P.U.D. PLAN

THE RESERVE AT WESTOVER HILLS 12/14

Re: Reserve at Westover Hills

POADP # 622-B

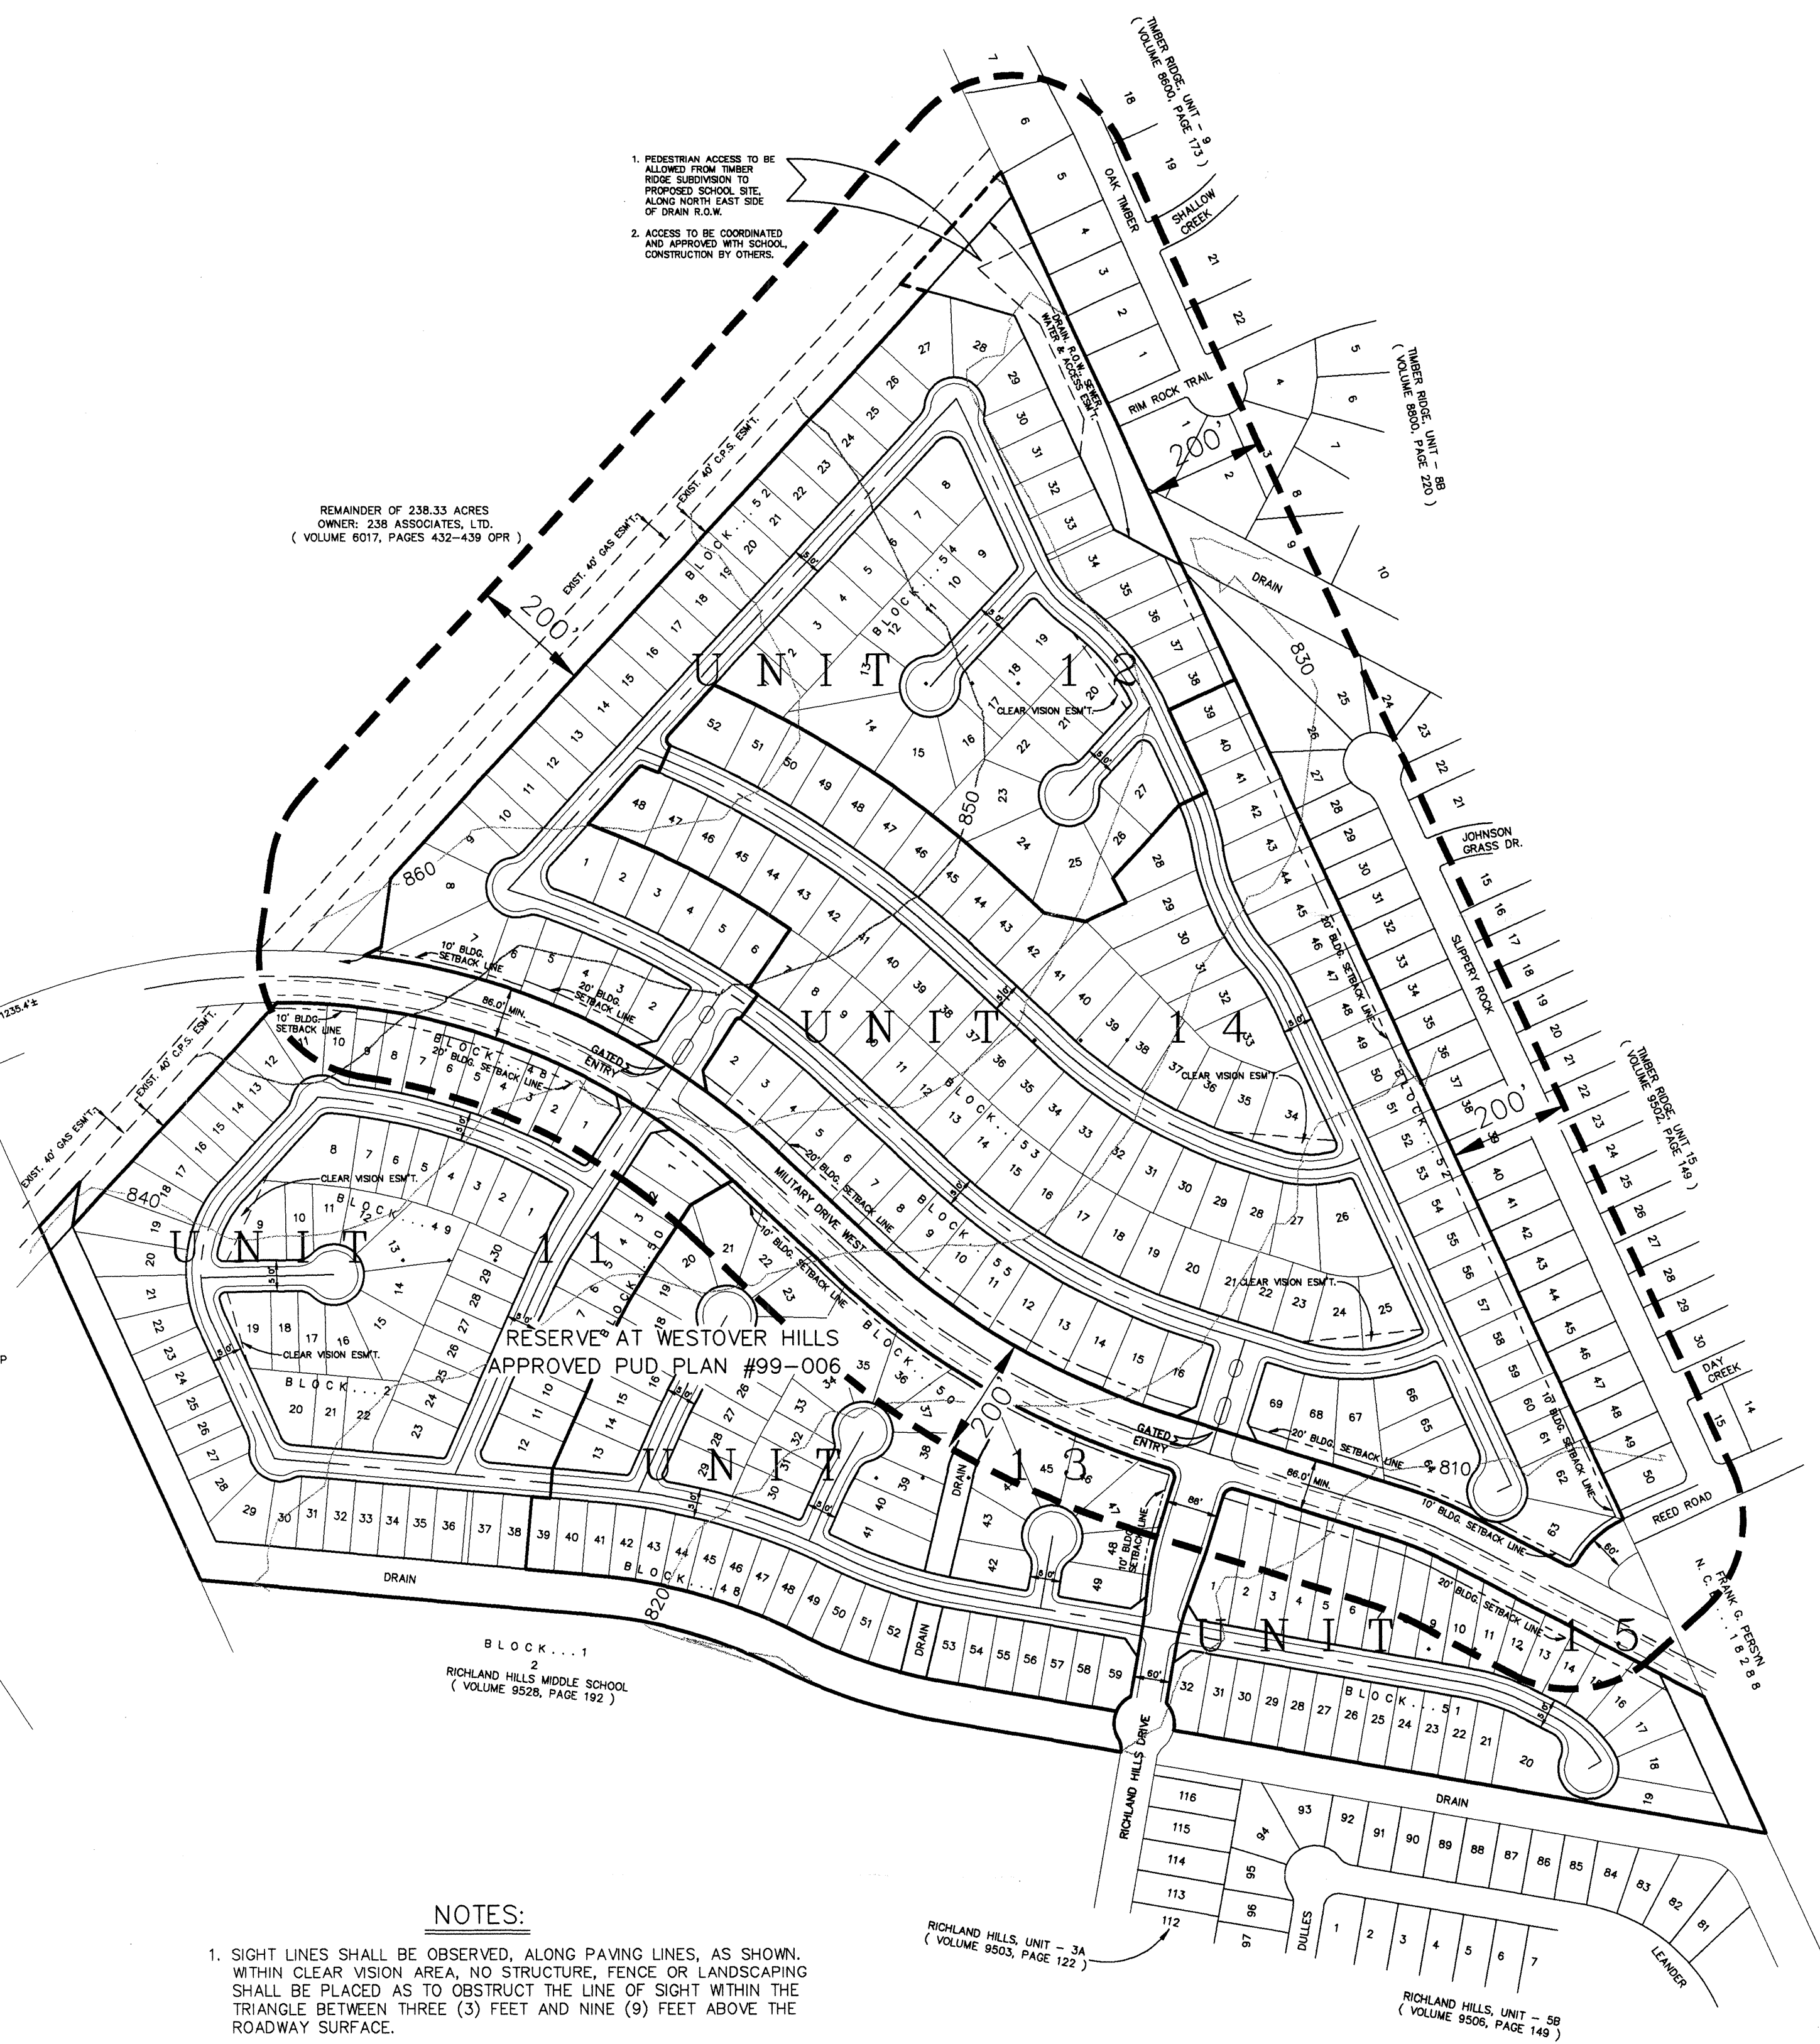
The City Staff Development Review Committee has reviewed Reserve at Westover Hills Subdivision Preliminary Overall Area Development Plan # 622-B. Please find enclosed a signed copy for your files. Although the northern portion (area north of Military Drive West) of your plan was accepted, please note the following:

- Based on the topography, a Flood Plain Study and drainage review will probably be required during the platting process.
- A variance will be required for Rim Rock Trail and Misty Rock at the time of plat submittal regarding projection of street.
- This development will need to comply with tree preservation ordinance #85262. For information about these requirements you can contact Building Inspections at 207-7102.
- It will be expected that you will plat all of the property depicted in your POADP, to include: floodpains, drainage areas and open space.
- I would encourage you to work closely with the school district, so that they can plan accordingly.
